**Conway Planning Commission  
Staff Report**

**7:00pm • April 17, 2017 • 810 Parkway Avenue**

**CONWAY CITY PLANNING DEPARTMENT REVIEW  
EDGEWOOD PARK PUD  
SUBMITTED BY: REFORM DEVELOPMENT GROUP**

### CONWAY CITY PLANNING DEPARTMENT REVIEW SOUTH STERLING PUD, PHASE 1 SUBMITTED BY: HAMBUCHEN PROPERTIES

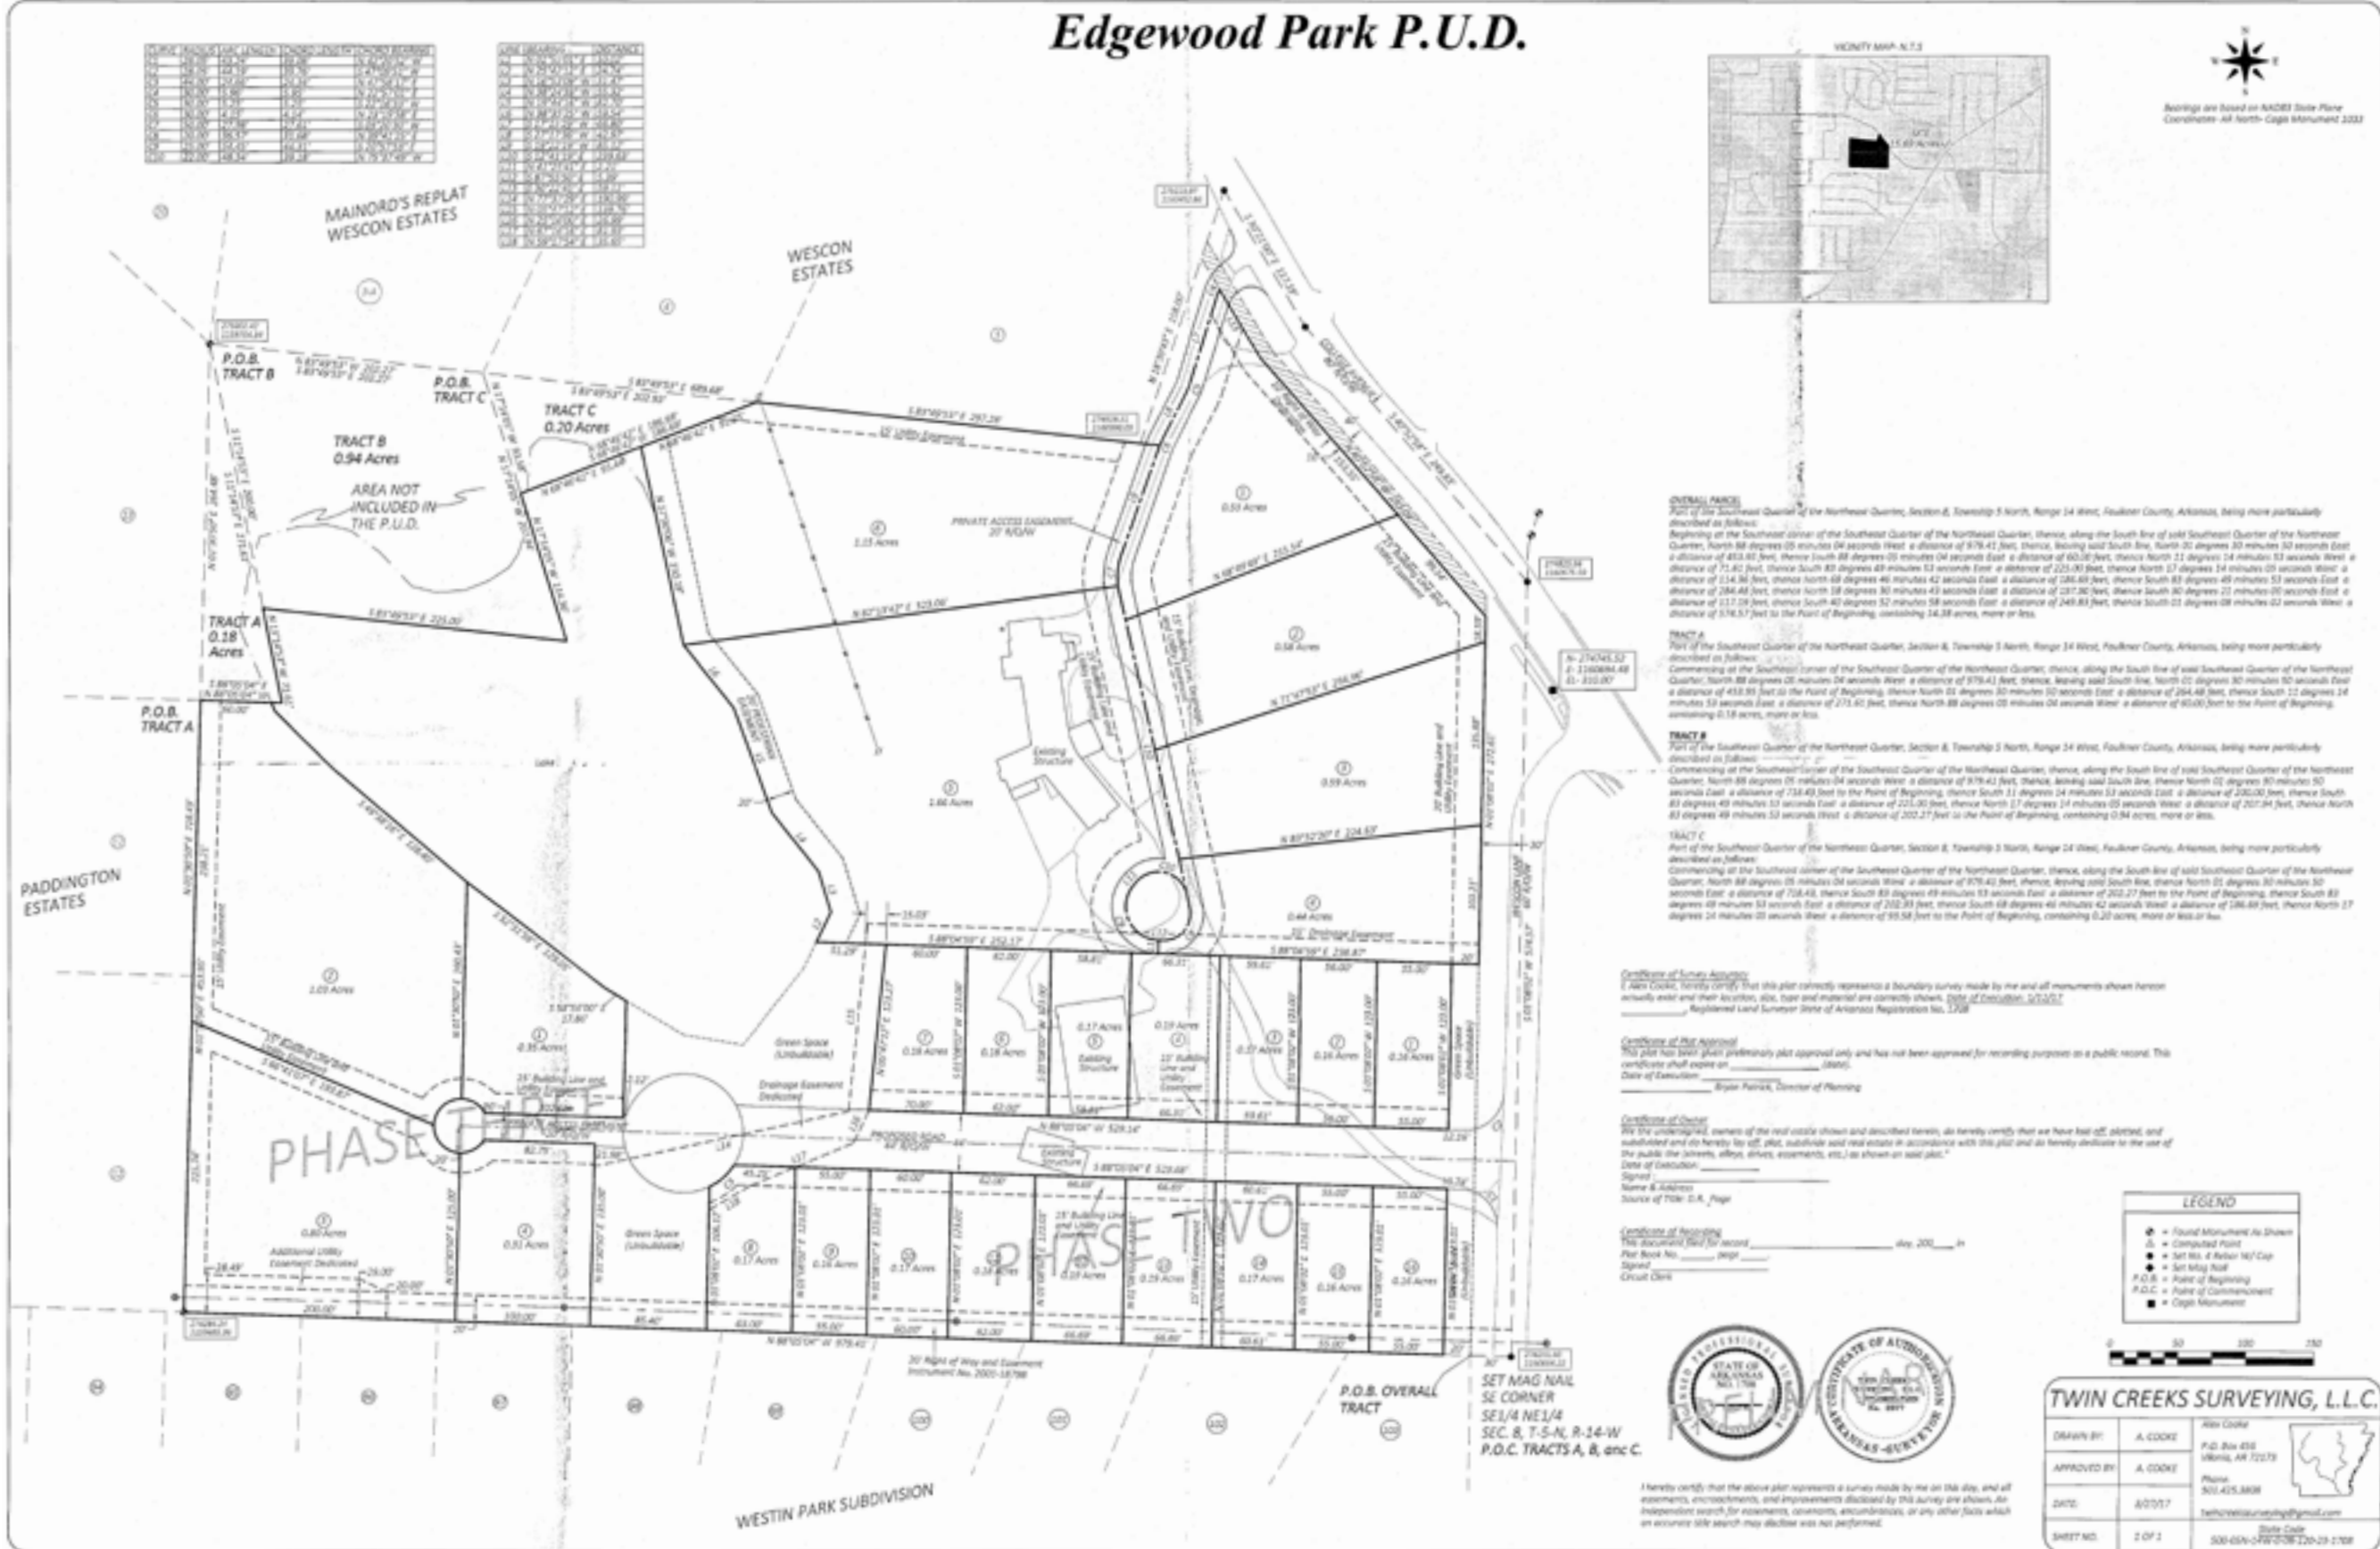
1. The name and address of all the owners of record are needed.
2. A legal description of the property with exact boundary lines, bearings and distances is needed. *Corrections per red mark copy.*
3. The present zoning classification, if any, of the land to be subdivided/replatted and of the adjoining land contiguous to the boundary of the proposed subdivision/replat is needed. *Additions and Modifications per red mark copy.*
4. The layout of all proposed sidewalk systems are needed, along with relevant dimensions and bearings.
5. Street names that are not similar to existing street names are needed for all proposed streets.
6. Proposed easements are needed. *Modifications to Easements per red mark copy.*

7. The source of water supply must be shown.
8. The method of disposal of waste water must be shown.
9. A phasing plan outlining the boundaries for each phase and the location of all CAGIS monuments for the subdivision is needed. A minimum of two CAGIS monuments shall be placed in each subdivision or subdivision phase exceeding ten (10) acres.
10. The Certificate of Preliminary Survey Accuracy is needed. *Add "Preliminary"*
11. The Certificate of Preliminary Plat Approval is needed. *Add "Preliminary"*
12. *Lot numbers for the Green Space, unbuildable lots and lake are needed.*

32. The rights-of-way of all streets must conform to the Master Street Plan and the requirements of Table 1, Street Classification & Design Standards, City of Conway in the Subdivision Ordinance. *Note Reduced 44' ROW per PUD.*

35. Cul-de-sac turnarounds shall have a right-of-way diameter of 120 feet and a pavement diameter of 96 feet. Measurements assume back of curb to back of curb for a roll curb. *Preliminary Plat approval contingent on Fire Department approval for the Private Drive and proposed street turn arounds.*

36. Property line corners at street intersections shall be rounded with a radius of at least 28 feet. *Lot 1 Phase I and Lot 1 & 16 Phase II.*

39. Corner lots shall have a setback of 25 feet from the front lot line and 25 feet from the exterior side lot line, or as required by the Zoning Ordinance. *Lots 1 & 16 of phase II to be a 0' building setback using the 20' unbuildable lot as the setback.*

40. Corner lots shall be at least 75 feet in width at the building line. *Lots 1 & 16 of Phase II incorporates the 20' unbuildable lot as part of the required width for building setback.*

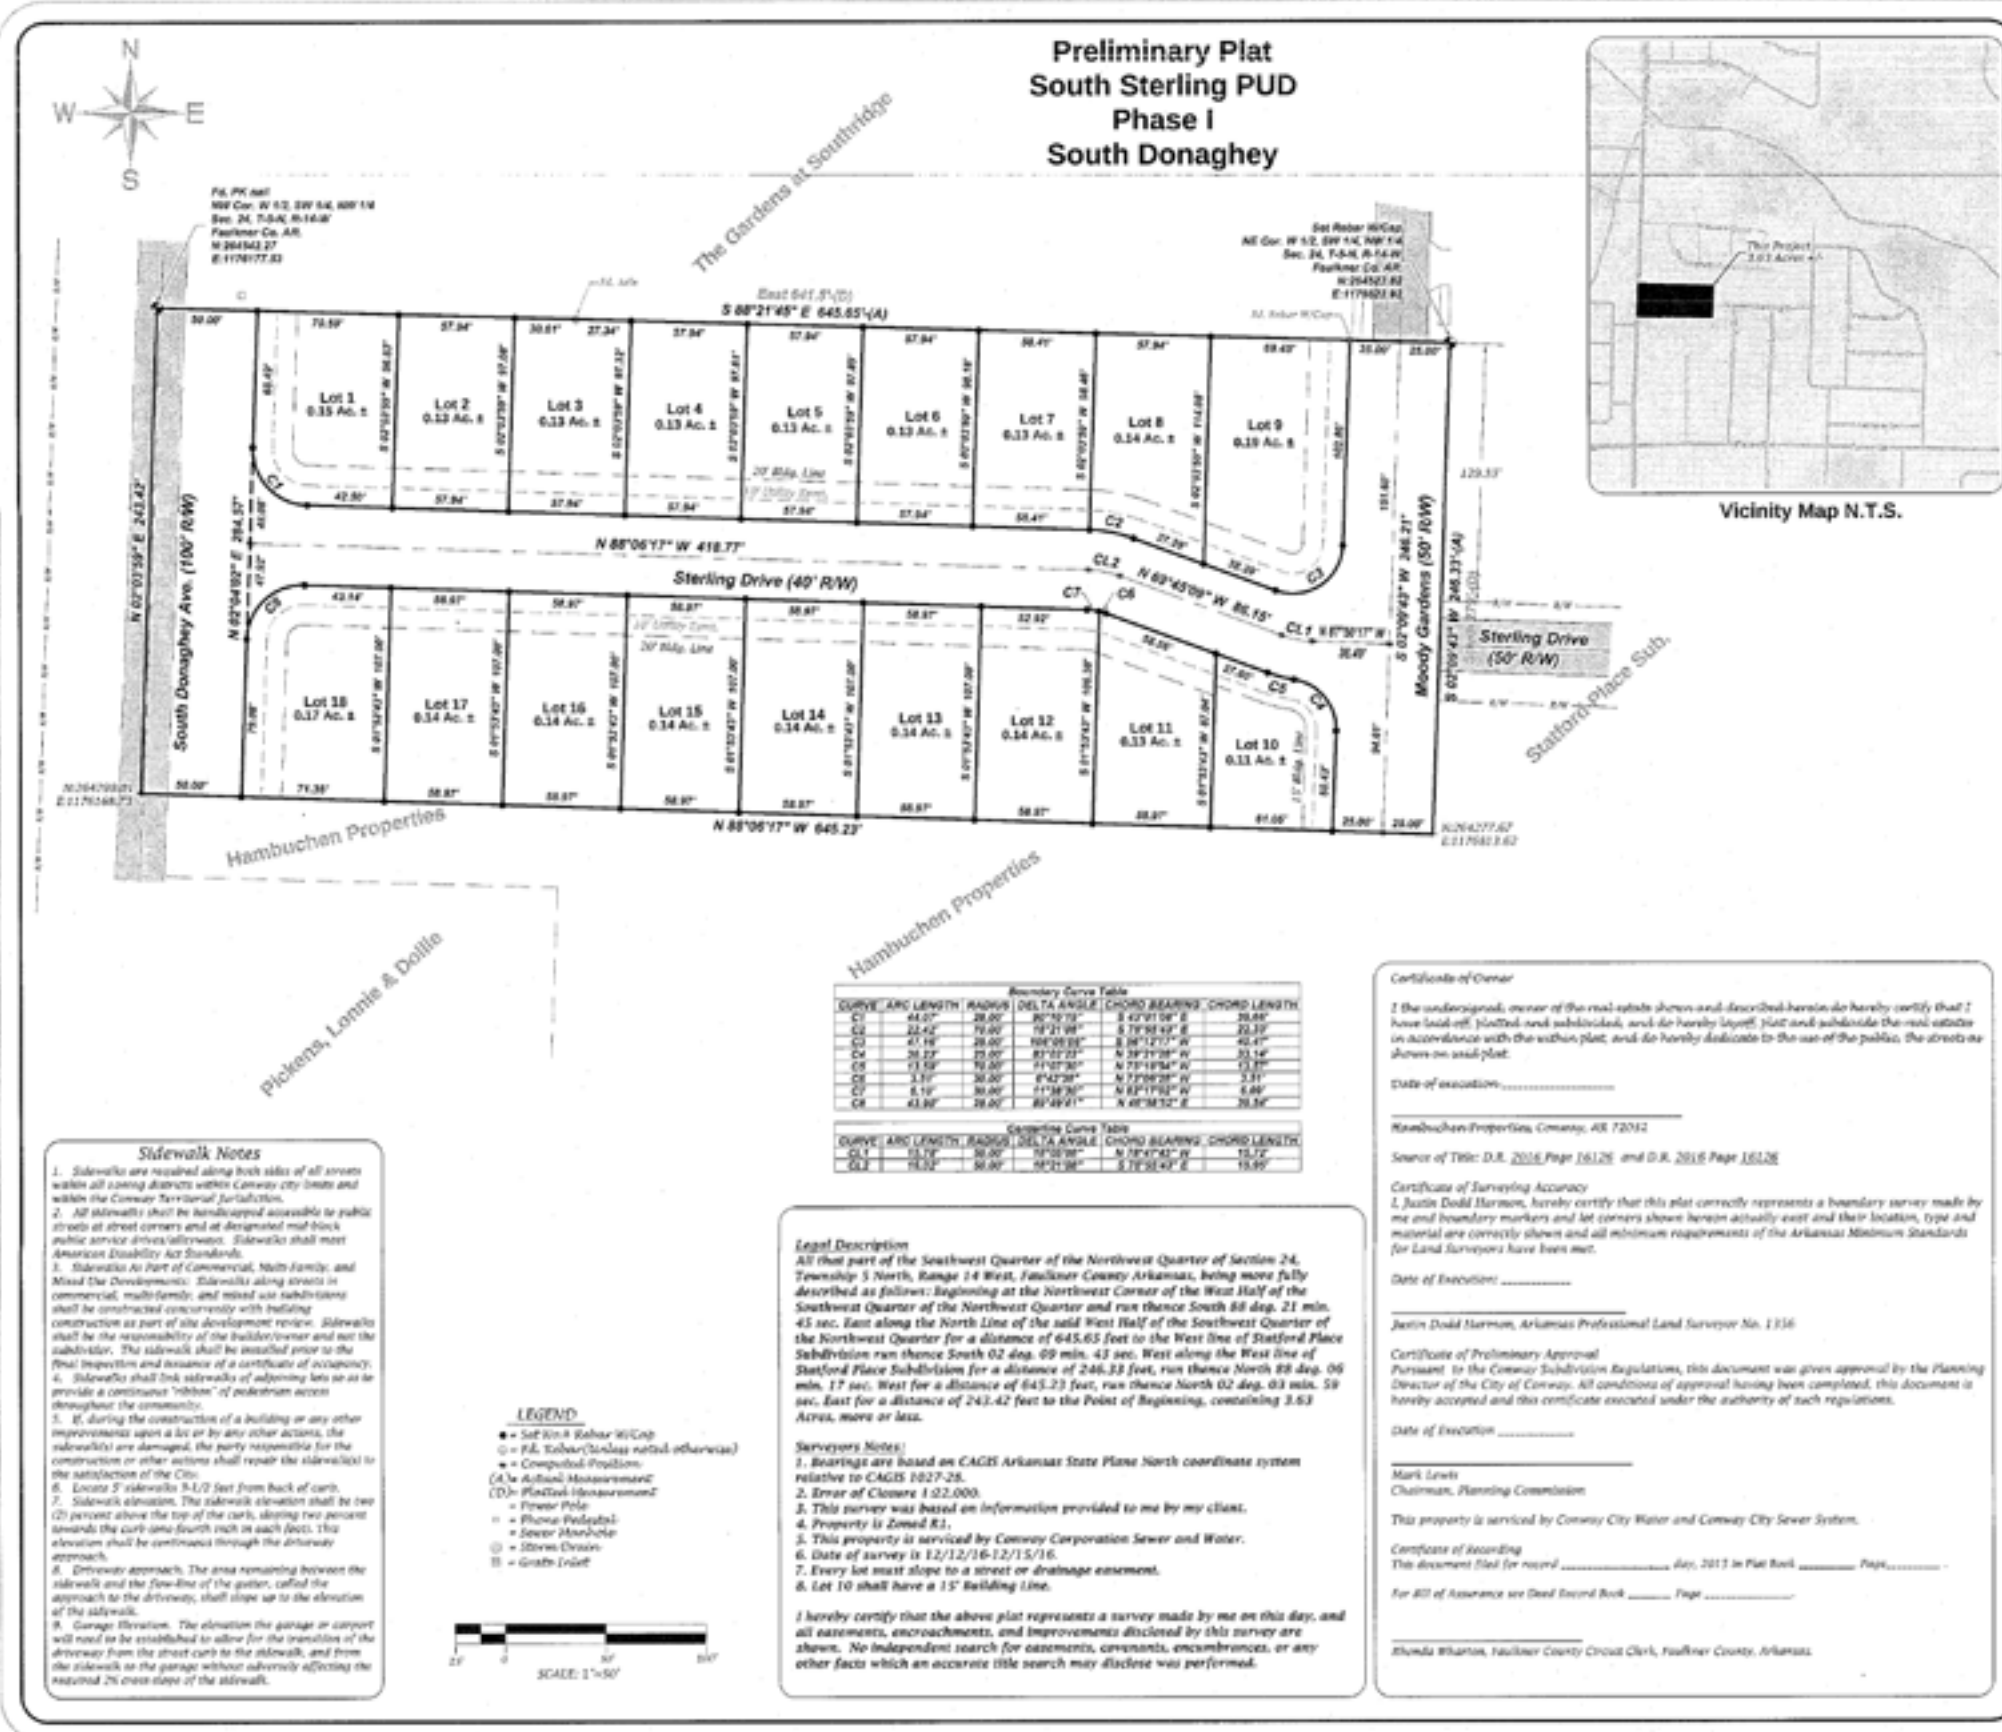
- 21. The rights-of-way of all streets must conform to the Master Street Plan and the requirements of Table 1, Street Classification & Design Standards, City of Conway in the Subdivision Ordinance. **Sterling Drive has been requested to be a 40' ROW in lieu of 50'. Planning Commission approves, contingent on Engineering review and approval / does not approve this request.**

- 23. The Planning Commission may authorize a new boundary street when the subdivider agrees to dedicate the entire right-of-way and construct all the required improvements. **Moody Gardens to the south creates a boundary street. Planning Commission must approve this request or this condition must be corrected.**

- 24. Street intersections shall be laid out as nearly at right angles as possible, with no angle of less than 75 degrees. **Sterling Drive and Moody Gardens intersection appears to be less than 75 degrees. Planning Commission approves, contingent on Engineering review and approval / does not approve this request.**

- 27. The minimum building setback (building line) shall be no less than 25 feet from the right-of-way of the front street, or as required by the Zoning Ordinance. *Building Setbacks of 20 feet matches plan approved by Counsel. Exception for Lot 10 is made below for a corner lot. Set back lines should be shown on the Final Plat for recording.*
